3 July 2015

Edition 13

AUSTRALIAN NOTICES TO MARINERS

Notices 708 - 765

Block for chart Aus 324

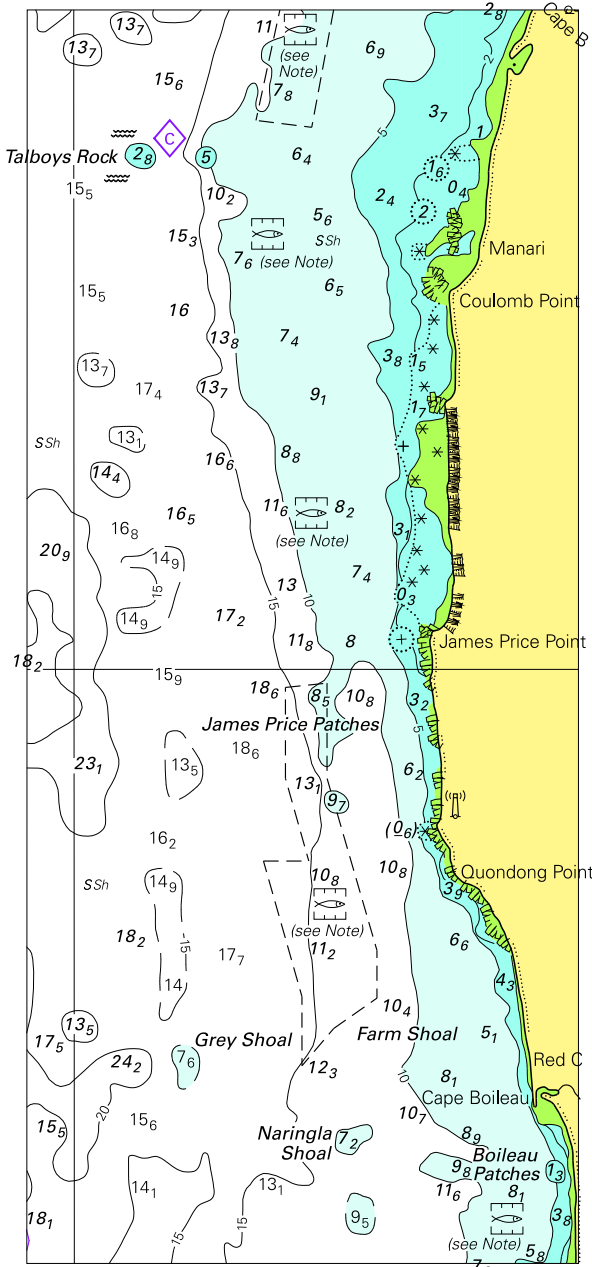
728* AUSTRALIA - WESTERN AUSTRALIA - James Price Point - Depths
Woodside Energy Ltd (DHDB 2577902)

Insert accompanying block 17° 30'.0 S 122° 05'.0 E

Block for chart Aus 4723 © Commonwealth of Australia 2015

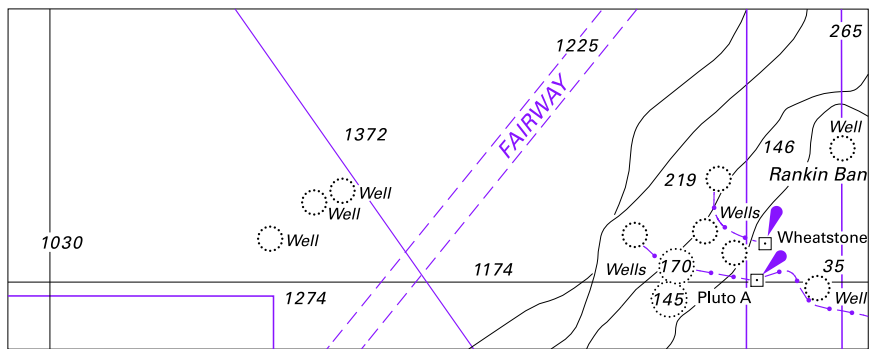
729* AUSTRALIA - WESTERN AUSTRALIA - Montebello Islands - Infrastructure northwestwards
Chevron Australia Pty Ltd (AA806181, AA813223)

Insert accompanying block 19° 51' S 114° 57' E
